SECTION 00 91 16: SUPPLEMENTAL SHEETS

**Southern Wayne High School – HVAC Renovations & Window Replacement
Dudley, North Carolina**

End of Addendum #3
Issued: October 16, 2023

M212

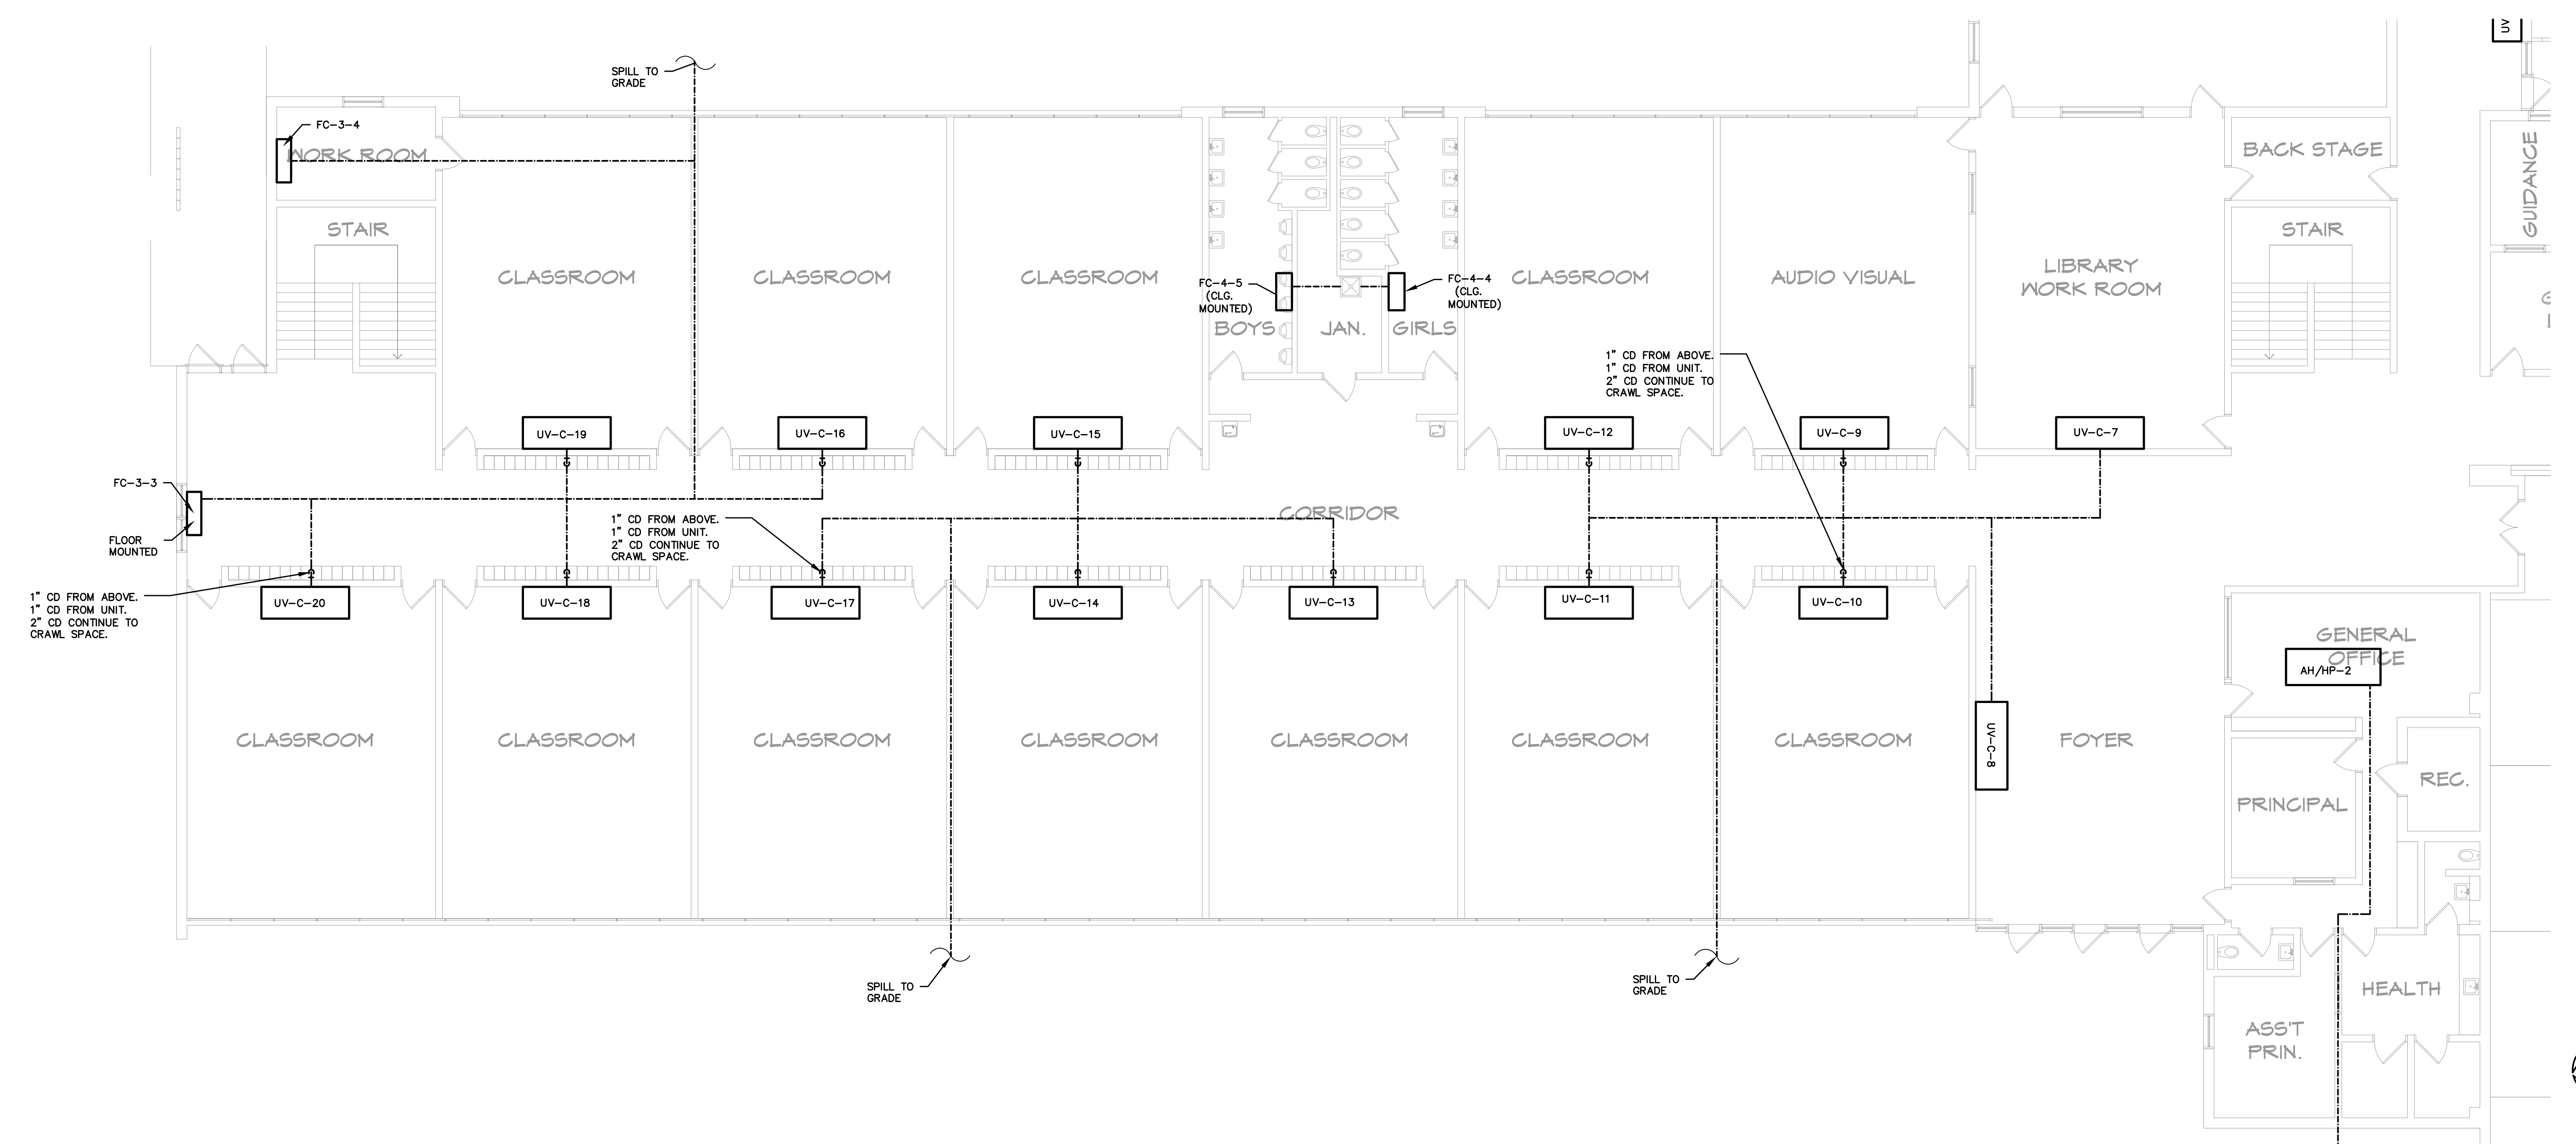
- D. SHEET M212 - FLOOR PLANS – AREA C & D CONDENSATE DRAIN ONLY – Delete this sheet in its entirety and replace with SHEET M212 - FLOOR PLANS – AREA C & D CONDENSATE DRAIN ONLY – Addendum #3 dated October 16, 2023. Sheet issued to clarify location of condensate drains. Drains from ceiling mounted unit ventilators will drop in the corridor locker. Floor mounted unit drains shall connect to risers in crawl space and discharge to grade. All condensate pipe in crawl space shall be 2”.

**SOUTHERN WAYNE HIGH SCHOOL
RENOVATIONS
DUDLEY, NORTH CAROLINA**
2nd FLOOR PLANS - AREA C
CONDENSATE DRAIN ONLY

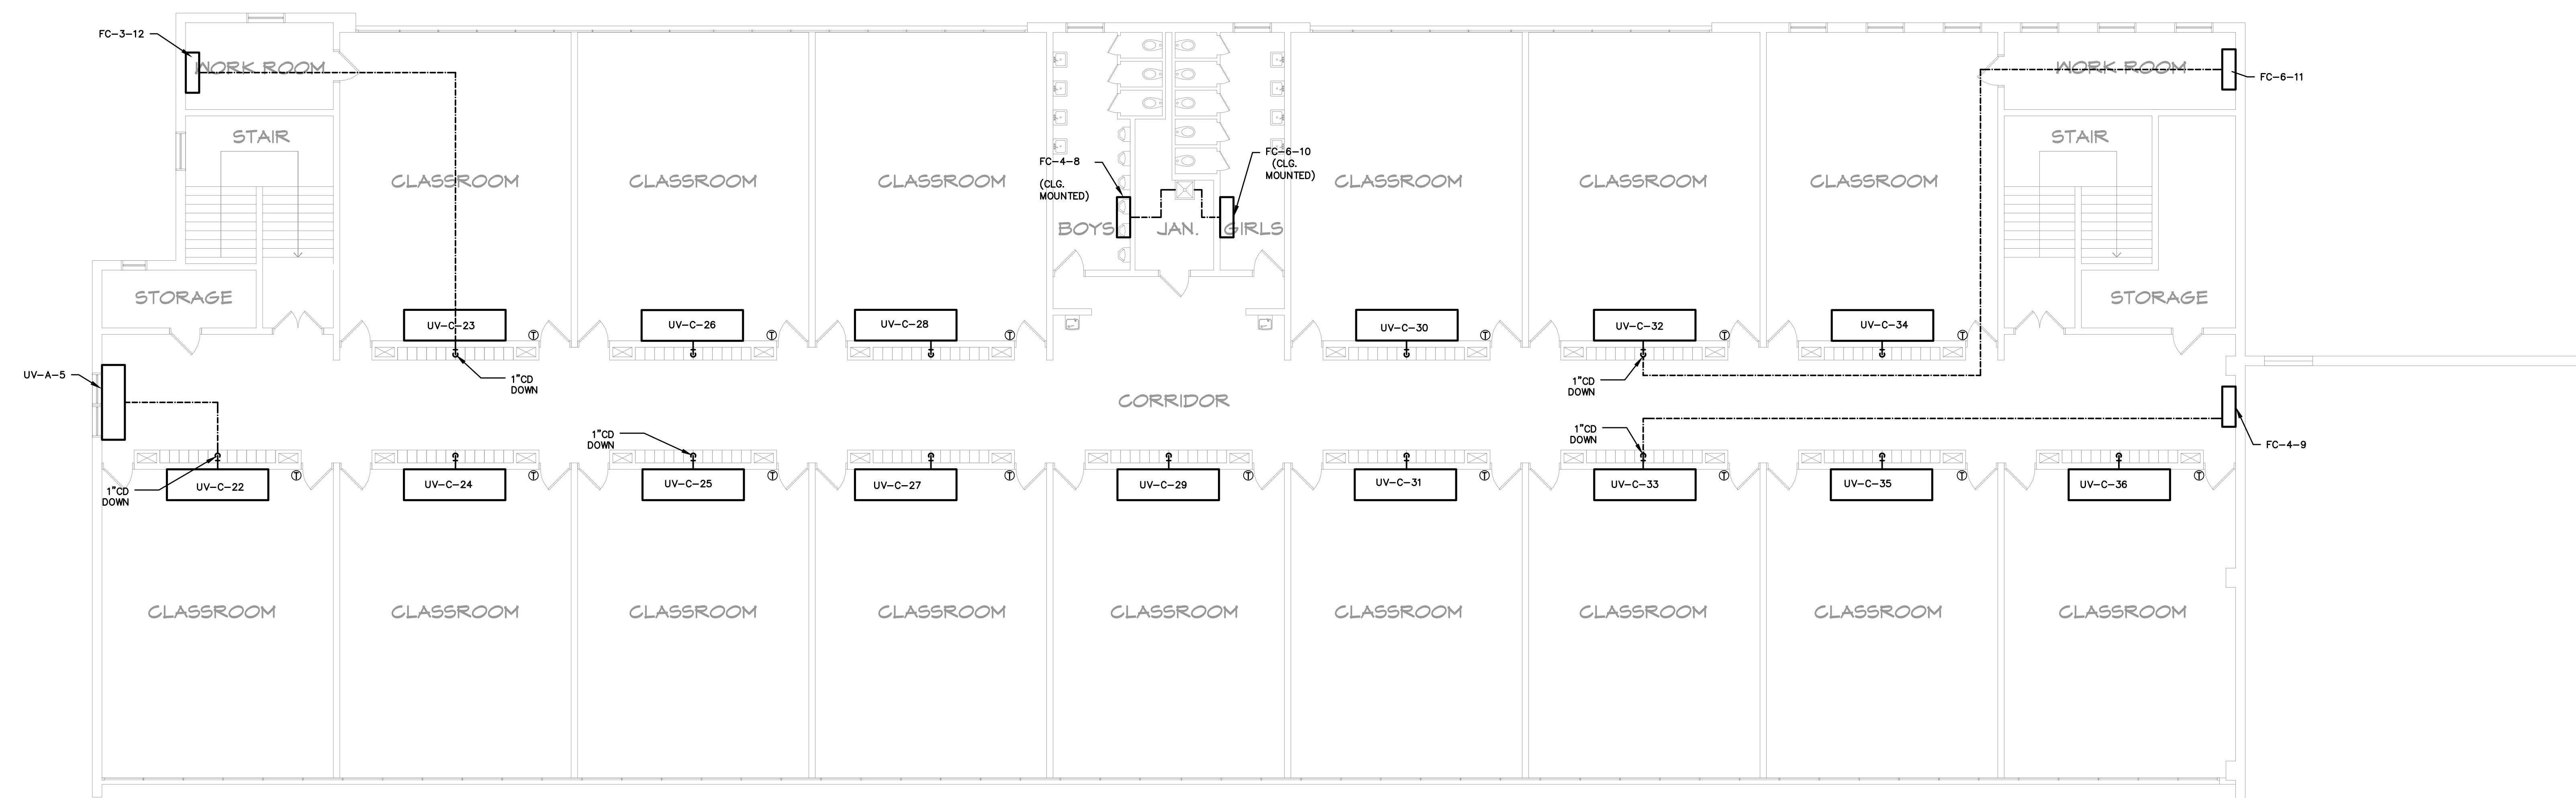
- E. SHEET M213 - 2nd FLOOR PLANS – AREA C CONDENSATE DRAIN ONLY – Delete this sheet in its entirety and replace with SHEET M213 - 2nd FLOOR PLAN – AREA C CONDENSATE DRAIN ONLY – Addendum #3 dated October 16, 2023. Sheet issued to clarify location of condensate drains. Drains from ceiling mounted unit ventilators will drop in the corridor locker. Floor mounted unit drains shall run above the first floor ceiling and route to drain risers as shown.
